ADDENDUM NO. 2

Kau Water System Improvements – Phase 1

IFB No.: IFB-20-HHL-019

DWG. NO.
C-13
SHEET 15 OF 54

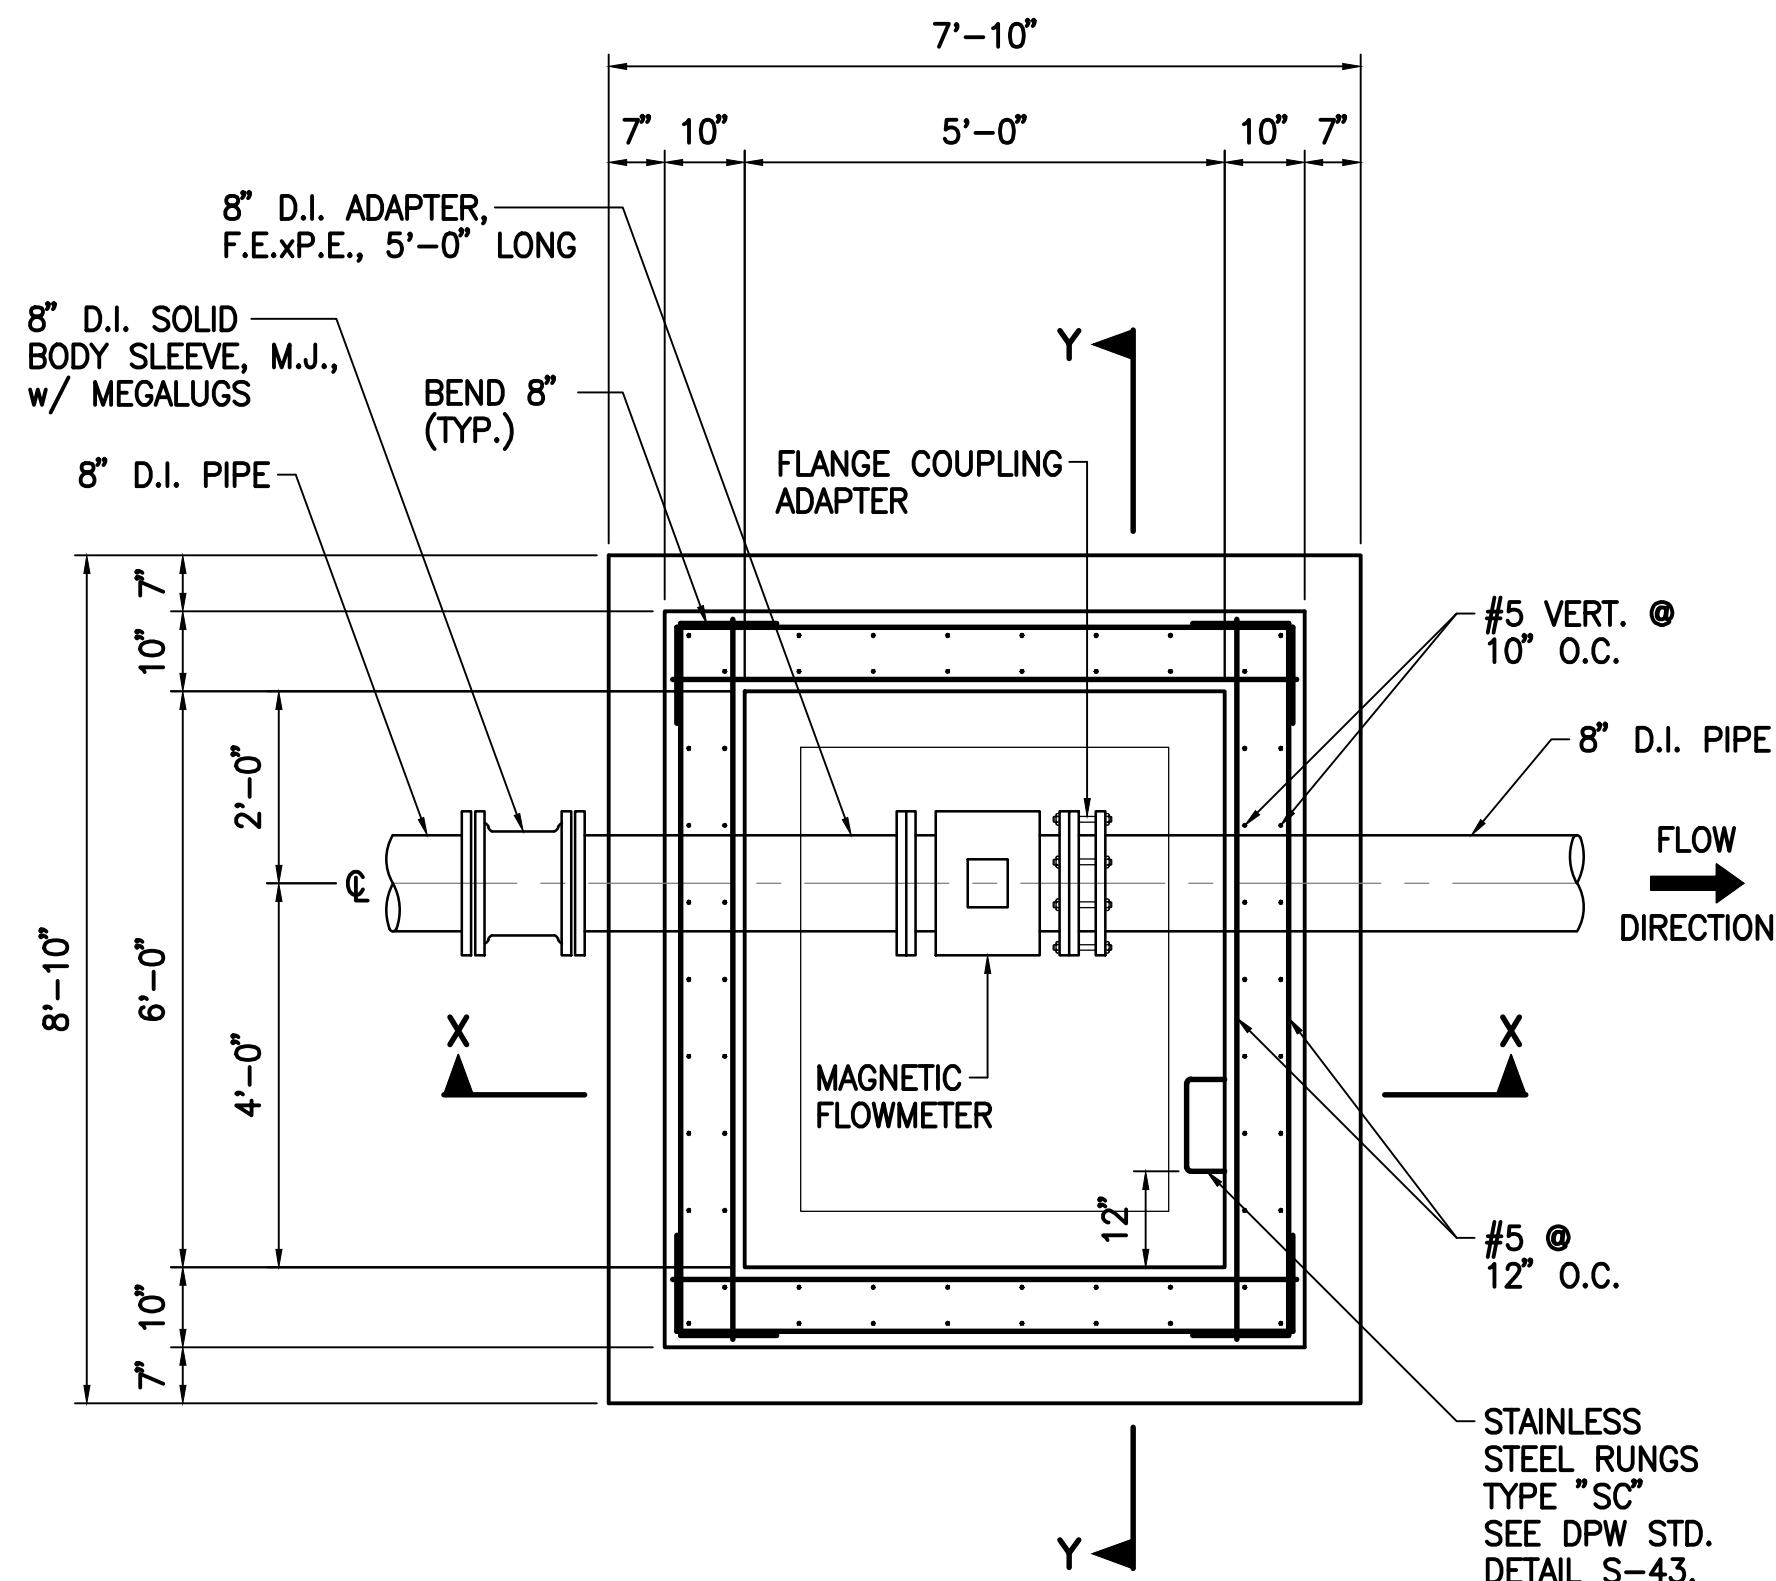
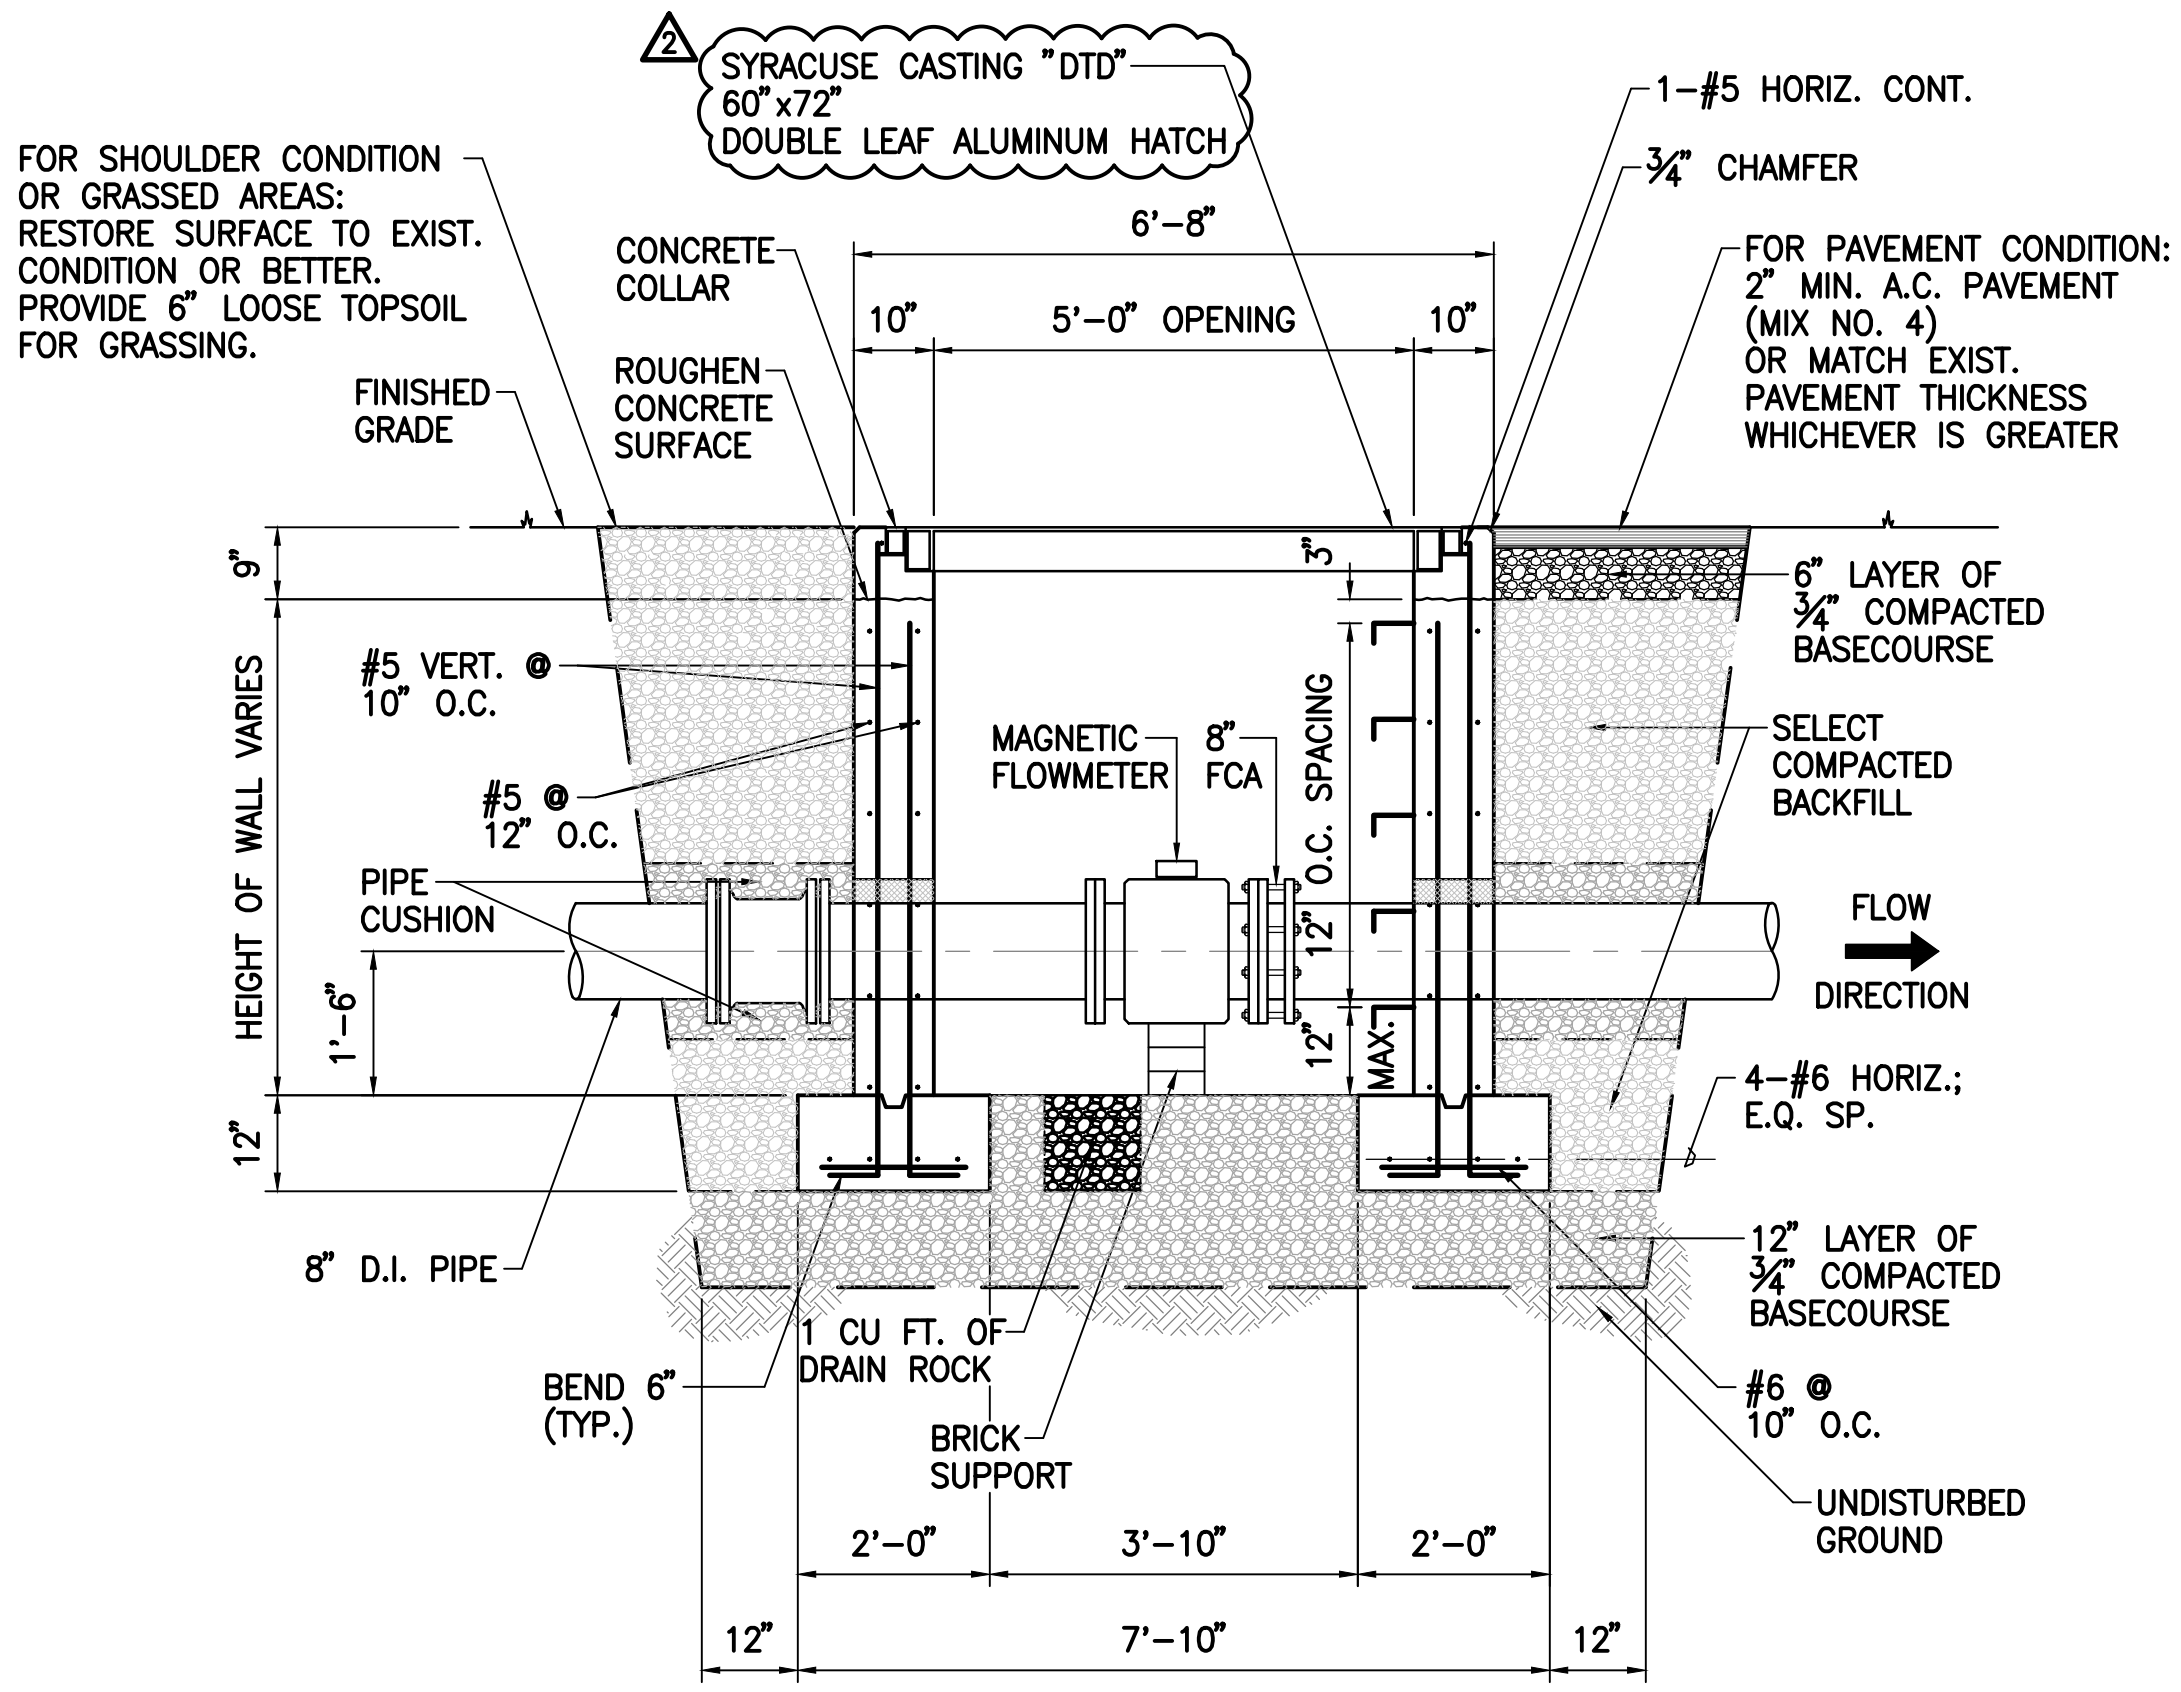
9. PLANS: Drawing No. C-13 - Revisions include deleting the Pipe Strap Detail for the 4-inch pipe and deleting the H-20 traffic rating for the flow meter vault access hatch.
